UNITED STATES
NUCLEAR REGULATORY COMMISSION
WASHINGTON, D. C. 20555

SUBJECT: COMMENTS ON A DPV CONCERNING EARLY BLOWDOWN CLADDING
RUPTURE DURING A LARGE BREAK LOCA

Comments on a DPV Concerning Early Blowdown
Cladding Rupture During a Large Break LOCA

FIGURE 1. Nominal CSAU Case

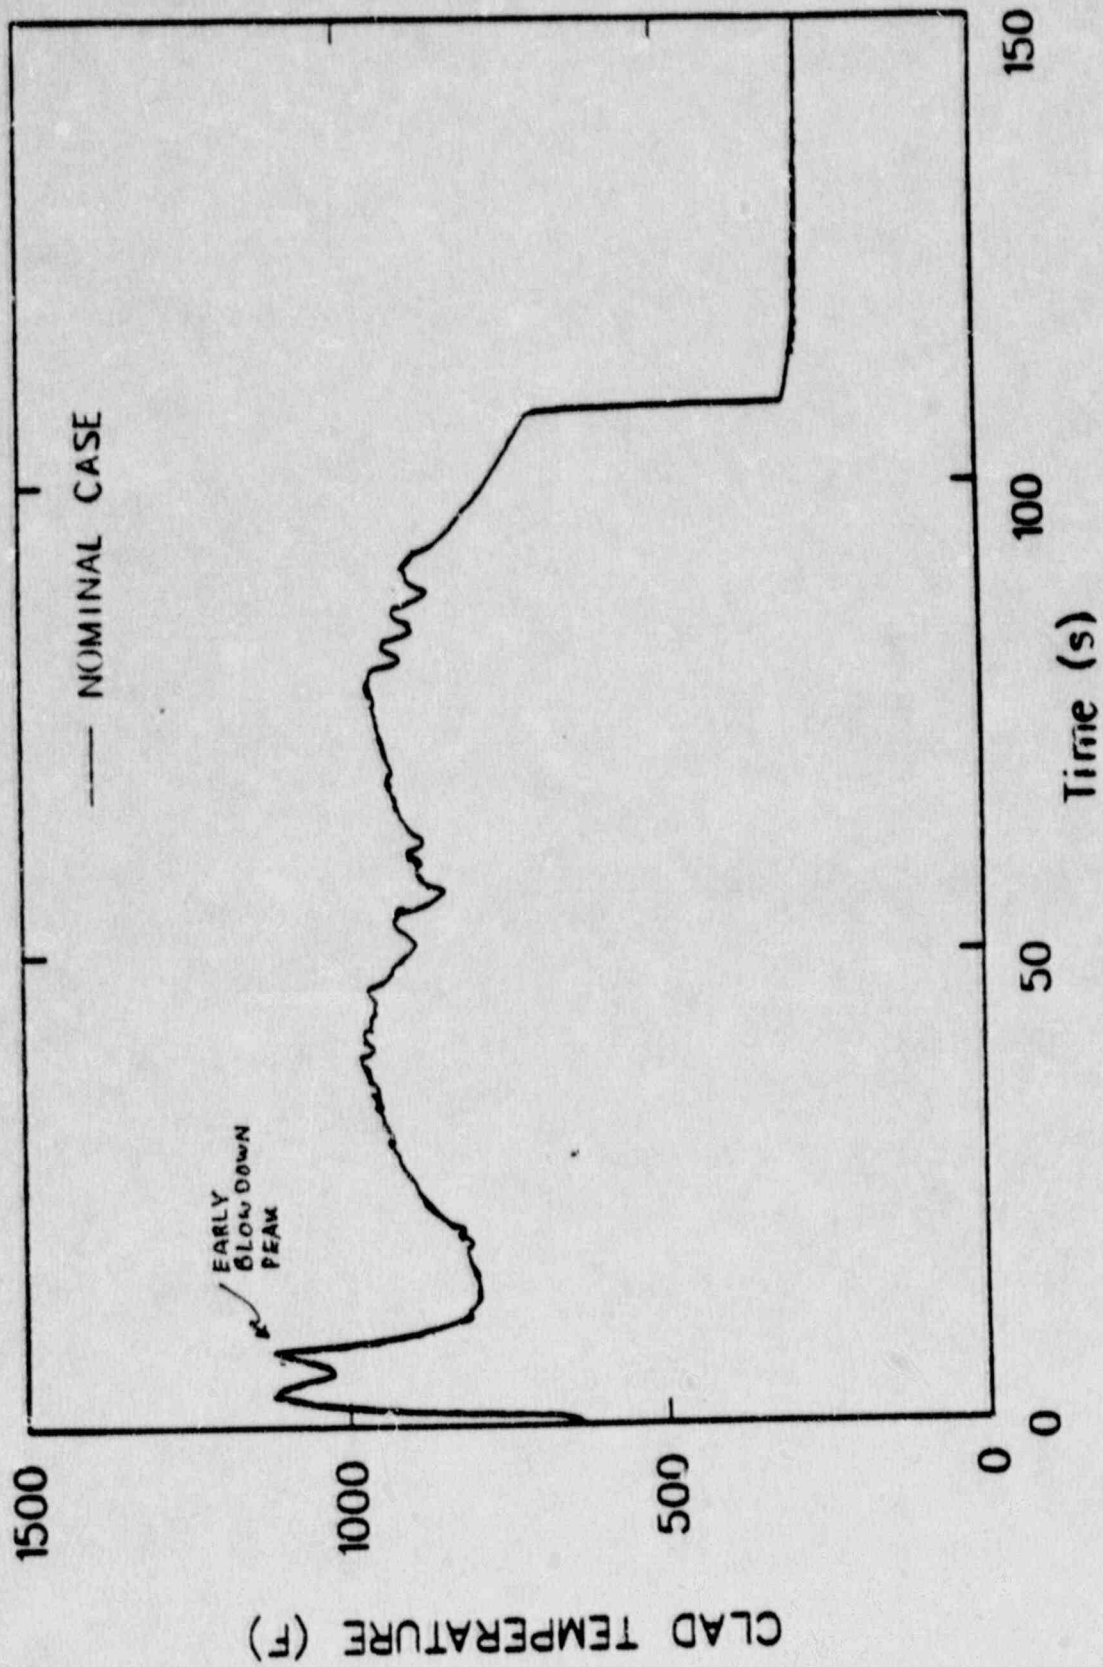
Issue 2 (p. 3-2) - "This shows that on infringement of DNBR at 1/10 second, average clad temperature increase very rapidly from a normal operating value of 720°F to at least 1350°F, and then to 1750°F, over a total period of seven seconds."

1750°F is indeed a very high early blowdown peak cladding temperature (PCT), but virtually impossible for a high burnup pin with a much lower PLHGR. If a high burnup pin reached 1750°F, at 7 seconds it would most likely rupture. More realistic LOCA analyses have been performed as part of the Code Scaling, Applicability, and Uncertainty program in RES. A best estimate analysis was performed and code uncertainties evaluated for a large break LOCA (Reference 2). In order to accomplish this, sensitivity studies were performed which varied gap conductance, peaking factors, and several other variables. The plant used was a Westinghouse 4-loop 3411 MWT plant with 17x17 fuel and a low burnup of only 16000 MWD/MTU which resulted in a PLHGR of 9.35 kw/ft. The blowdown peak for the nominal CSAU case was 1103°F (see Figure 1). Based on over 250 clad temperature calculations and using Monte Carlo sampling techniques, it was determined that the 95th percentile blowdown PCT was 1447°F. It has been determined that 15x15 pins (as used at Zion) with burnups greater than 40,000 MWD/MTU have PLHGRs no greater than 6.4 kw/ft. Using the CSAU calculated sensitivity of blowdown PCT to LHGR, the value of 1447°F can be extrapolated to approximately 1320°F for the 6.4 kw/ft PLHGR high burnup 15x15 pin. This illustrates that the 1750°F blowdown PCT calculated by Westinghouse is quite conservative, especially for a high burnup pin. I believe that this Westinghouse calculation is probably at least 10 years old.

Figure 2. Comparison of measured and calculated fuel rod plenum pressure versus time for Rod 3 of PBF test LOC-3.

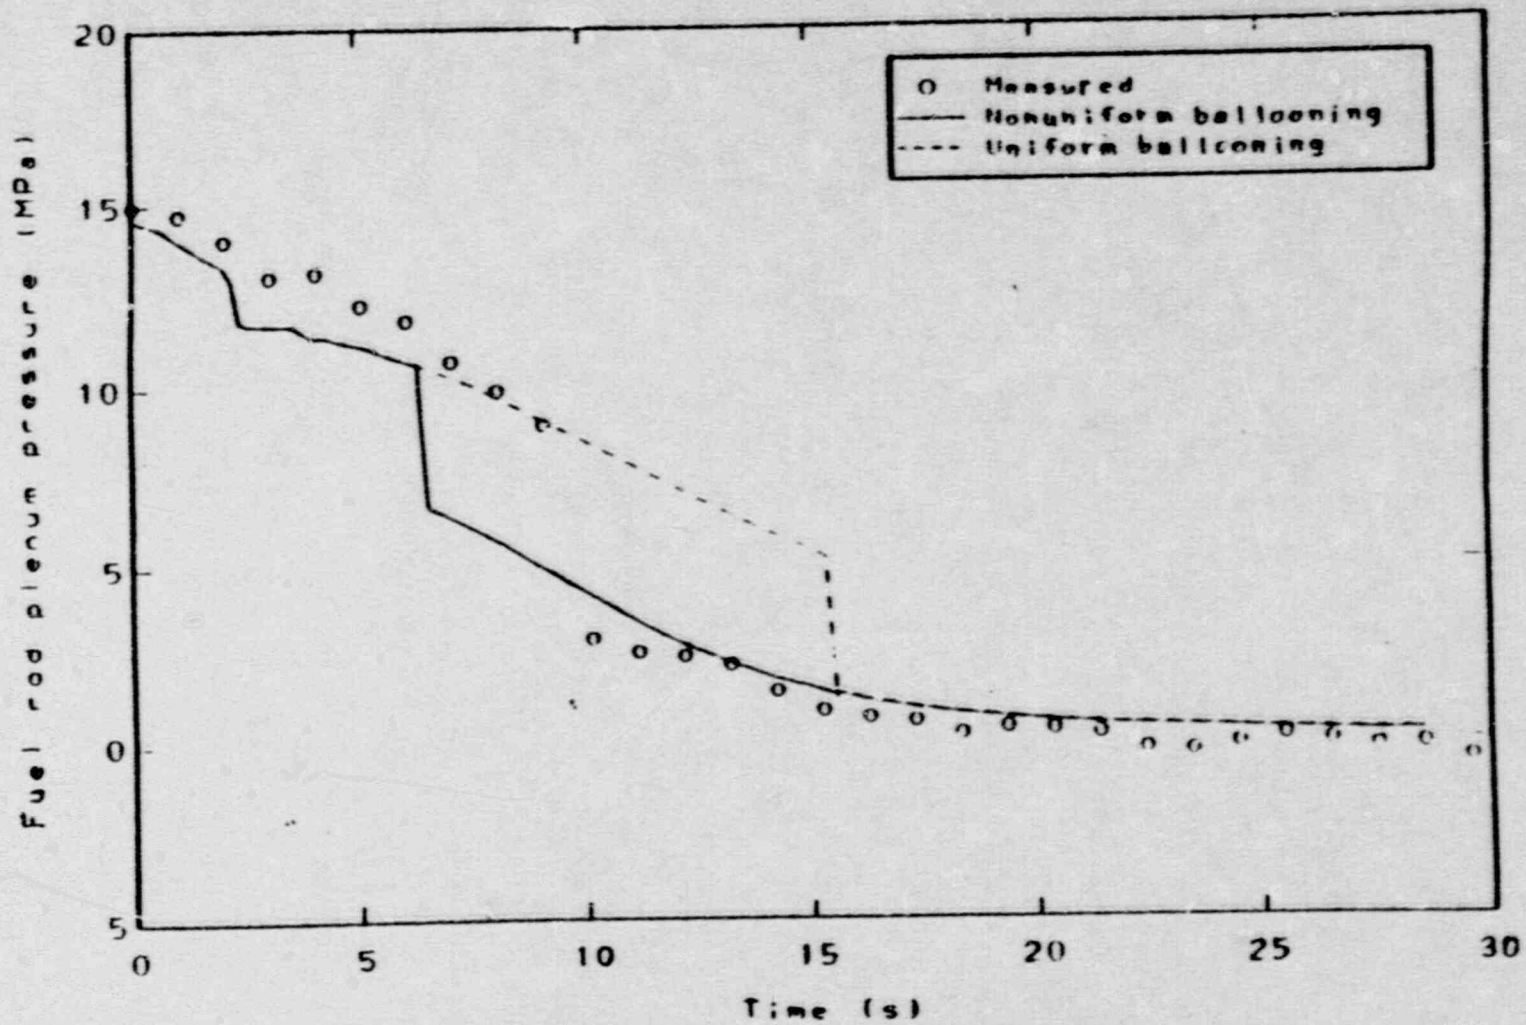
Issue 6 (p. 3-3) - "It is proposed that, immediately, on a LOCA as clad temperature increases to 1350°F, gap pressure will increase by 20%, to 1800 psig At 7 seconds into the event, clad temperature has increased further to 1750°F, From this, it can be proposed that gap pressure for the complete rod can increase by 36% over its normal operating value to 2100 psig."

The basis for concluding that pin pressure increases during an LBLOCA blowdown is not known and contrary to the evidence. A series of 3 large break LOCA simulations (Reference 3) (LOC-3, LOC-5, and LOC-6) were performed in PBF with well instrumented Zircaloy clad UO₂ fuel elements pre-pressurized to simulate low and high burnup PWR fuel. PBF blowdowns are quite severe compared to postulated PWR LBLOCA blowdowns. In PBF, the pressure decrease and rate of mass loss is very rapid. No good reverse flow blowdown heat transfer is evident as is the case in LOFT results or PWR analysis. Figure 2 (Reference 6) shows the fuel rod pressure for rod 3 in test LOC-3. Also, shown are FRAP-T6 calculations using two different plastic deformation models. Clearly, pressure decreases throughout the transient. Figure 3 is a plot showing measured pressure decrease for Rod 11 in Test LOC-6. A FRAP-T5 characterization calculation was done for a postulated LBLOCA in Zion (reference 7) which also showed a pressure decrease throughout the transient.

Figure 3. Thermal and mechanical response of Rod 11 during Test LOC-6.

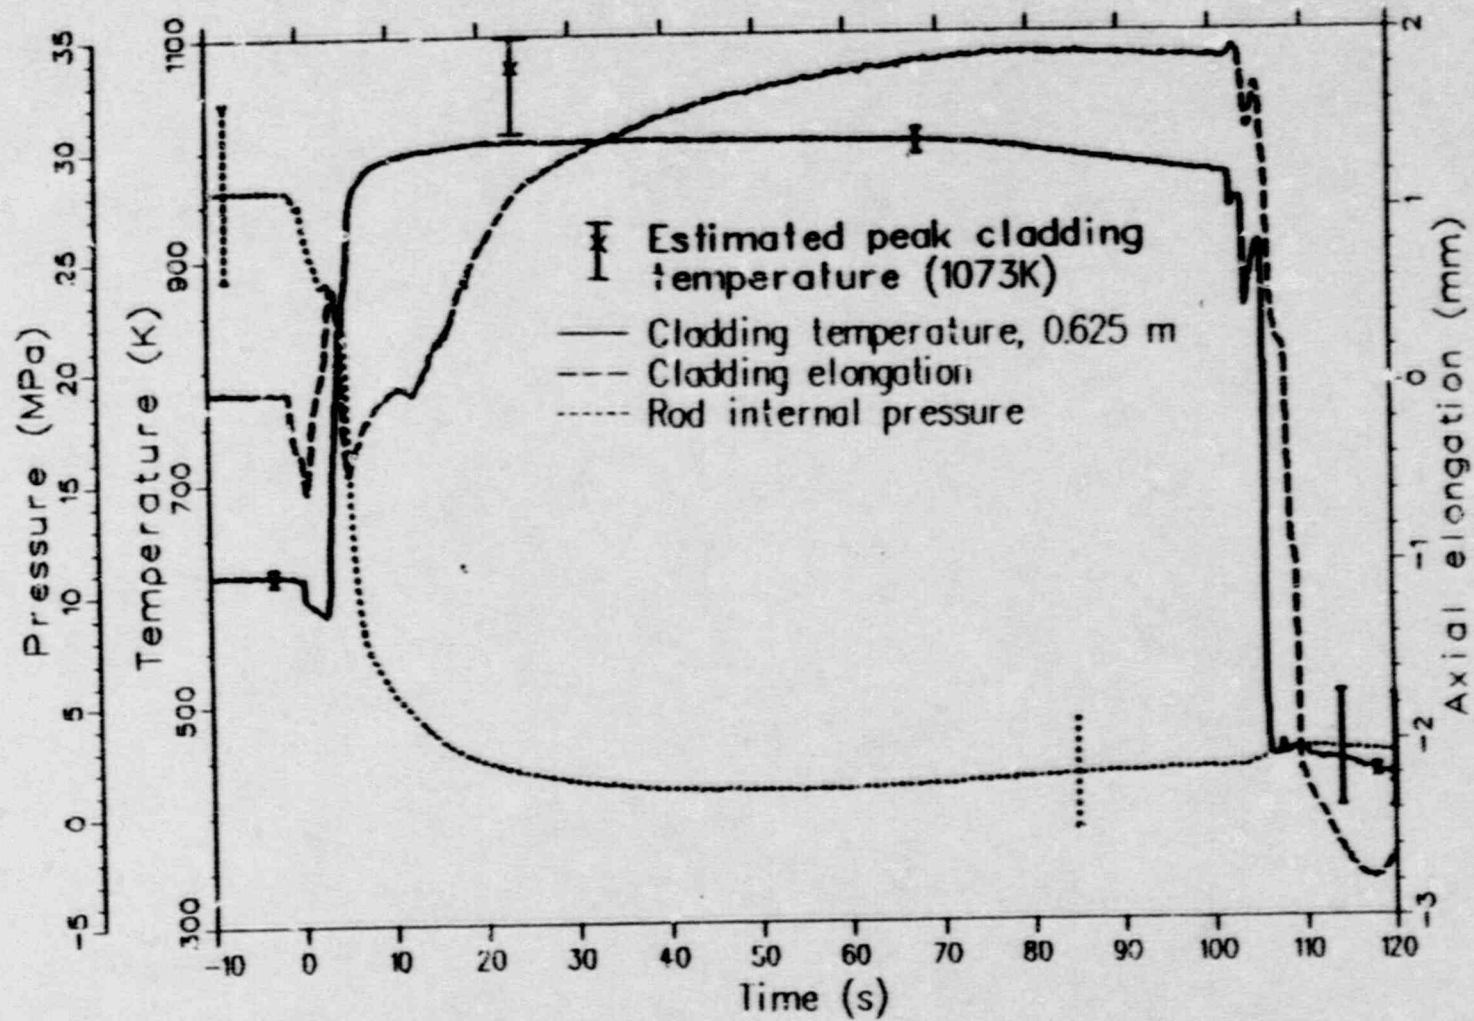
The main contributors to fuel cladding rupture are high pressure drop across the cladding and high cladding temperature. Early post-DNB cladding temperatures are determined to a very large degree by pre-accident stored energy which is a function of local peak power (PLHGR), pre-accident gap conductance, effective UO_2 thermal conductivity, blowdown heat transfer, and critical flow model. The CSAU study (Reference 2) confirmed this assessment. Of these variables, only PLHGR is controllable by plant operators, and then only to a limited degree. High burnup, third cycle fuel is always placed in low power regions. Pin pressure is determined by pre-pressurization and fission gas release. As shown in References 3 and 6, pin pressure does not exhibit a direct functional relationship to blowdown cladding temperature.

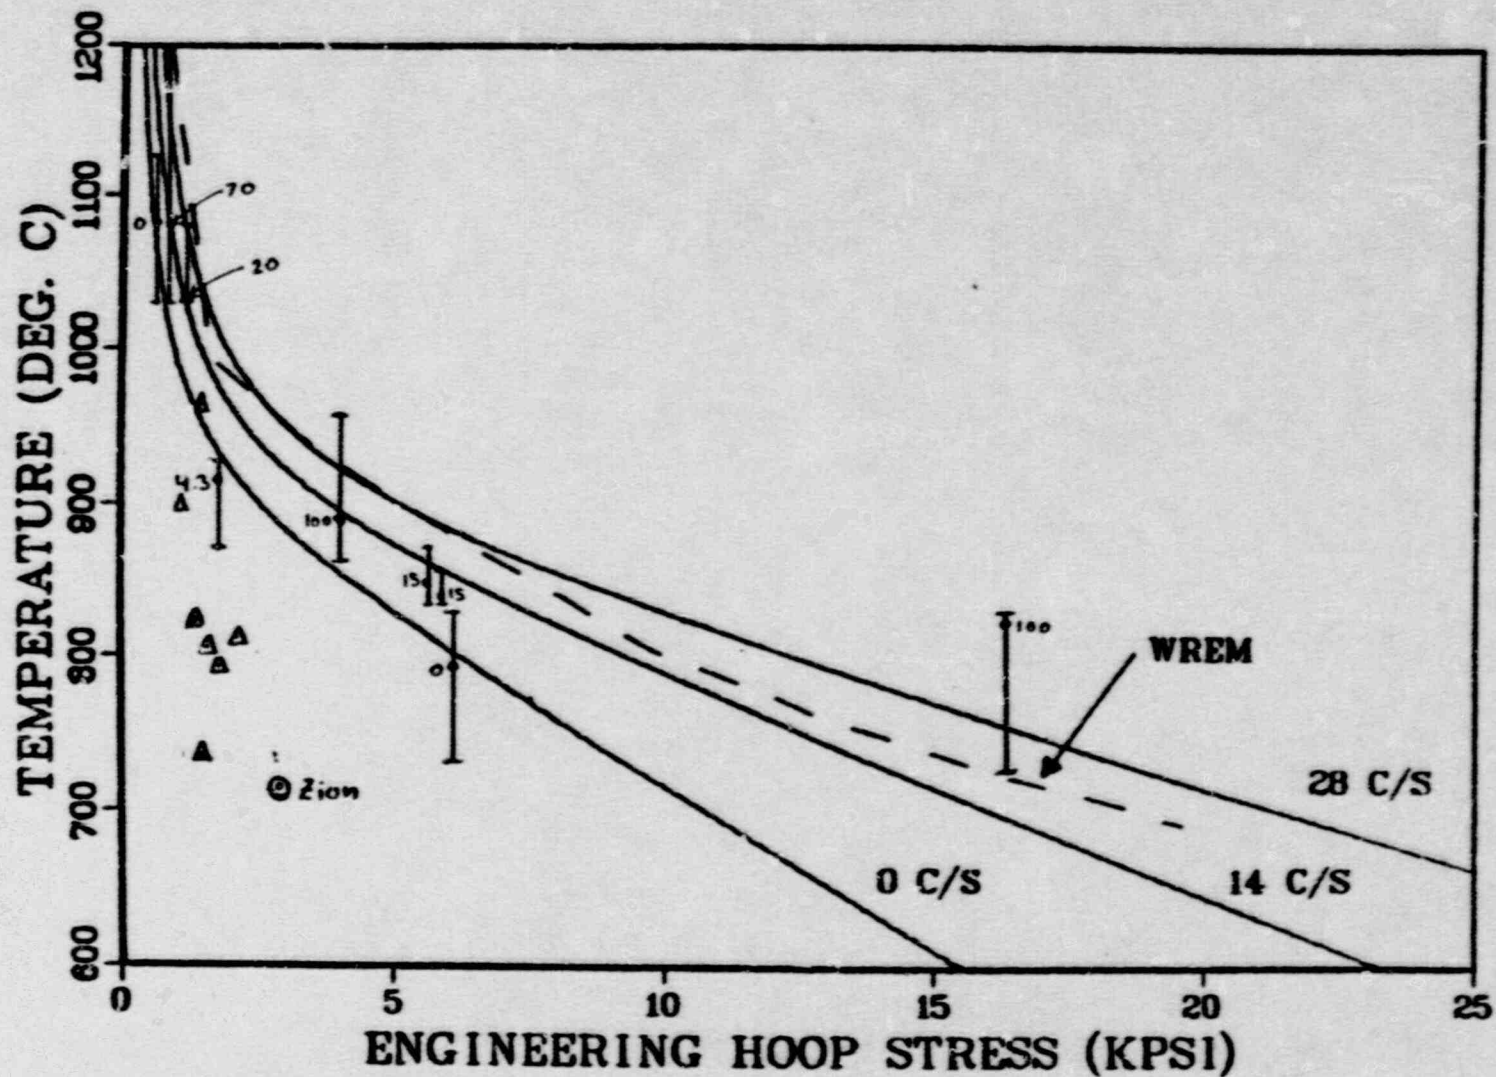
Issue 7 (p. 3-5) - Concern is expressed about the relevance of electrically heated rods used in defining the swelling and rupture curves in NUREG-0630. It is suggested that the TREAT data shown in NUREG-0630 (Reference 6) would be more realistic. Also, on pp. 4-3 and 4-4, this concern is restated.

It is clear that TREAT data is anomalous compared to the electrically heated rods and is attributed to difficulties in obtaining accurate temperature data in the burst region. A better source of in-reactor data is the PBF series discussed previously. Figure 4 is a plot from NUREG-0630 (Reference 8, Exhibit 16). Included are data points with temperature uncertainty for the 9 ruptured rods in the PBF LOC series of tests, and the FRF data from TREAT. It is clear that the more recent PBF data is very consistent with the NUREG-0630 curves.

PAD 3.4 calculations for a 15x15 pin were not performed in Reference 5, but by extrapolating a 17x17 PAD analyses using incremental values from Table 1, it is estimated that the pre-accident 15x15 pin pressure at end of cycle 3 would be about 1500 psi. Based on the pressure decrease calculated for the 15x15 pin in the first 5 seconds in Reference 7, it is estimated that the pin pressure at 5 seconds for a high burnup 15x15 pin would be 1300 psi. The system pressure at that time was determined to be 920 psi. The pressure drop across the clad is therefore 380 psi and the engineering hoop stress is estimated to be 3.0 KPSI. As shown in Figure 4, this is well below the NUREG-0630 curves and even below the TREAT data. Therefore, it is not expected that any high burnup pins which have low LHGRs would experience any early blowdown ruptures.
